Project	IEEE 802.16 Broadband Wireless Access Working Group < http://ieee802.org/16 >	
Title	Process and rules for development of SNMP solution sets	
Date Submitted	2006-07-19	
Source(s)	Krzysztof Dudzinski Airspan Communications Ltd Joey Chou Intel	[mailto:kdudzins@airspan.com] [mailto:joey.chou@intel.com]
Re:	Call for comments IEEE802.16i-06/001r2	
Abstract	<p>This contribution was written based on the material presenter, discussed and approved by SNMP solution ad-hoc group. Parts of the contribution proposing specific editorial changes to the document are based on material approved by ad-hoc group.</p> <p>Current process of developing 802.16i document doesn't cover the subject of maintenance of 802.16f. The strategy and process are inefficient in all aspects related to SNMP solution sets. This contribution proposes new process and rules to address those issues.</p>	
Purpose	Adopt the contribution and apply required changes in the text of 802.16i document.

Process and rules for development of SNMP solution sets

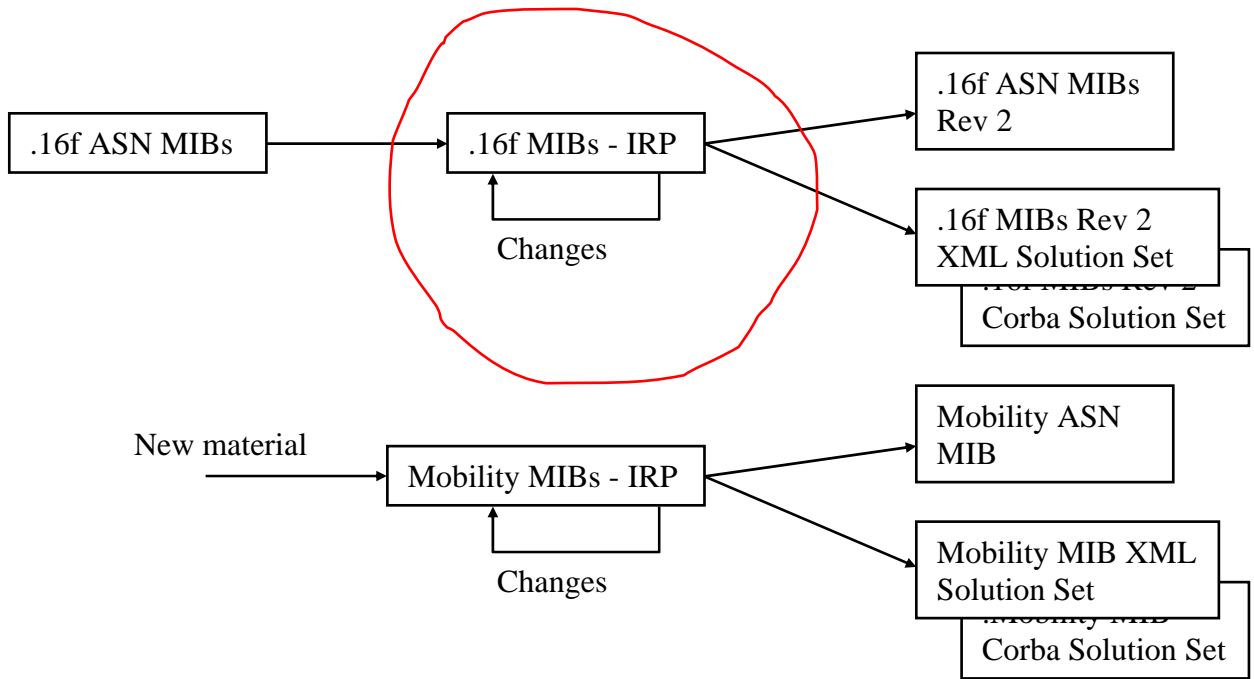
1) How many MIB modules do we plan to have defined in the standard?

1a) 2 MIB modules - current approach (wman2-if-mib and wman2-dev-mib) both redefining all objects defined in .16f MIBs

1b) 3 or more MIB modules – new approach assuming reuse of 802.16f MIBs and creating new MIB module for mobile extensions only

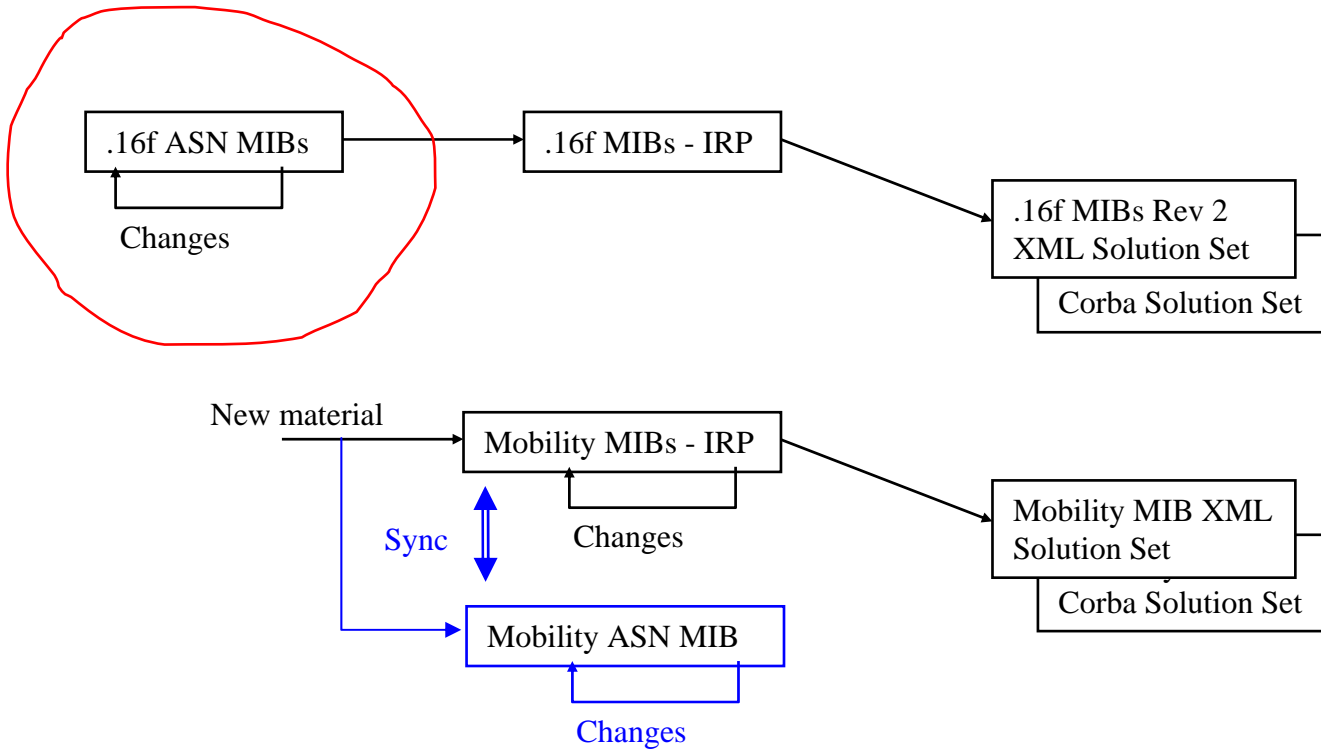
2a) Apply maintenance changes to IRP model after reverse engineering?

2b) Apply maintenance changes to ASN MIBs before reverse engineering IRP model and develop mobility MIB(s) in parallel using ASN.1 and IRP.
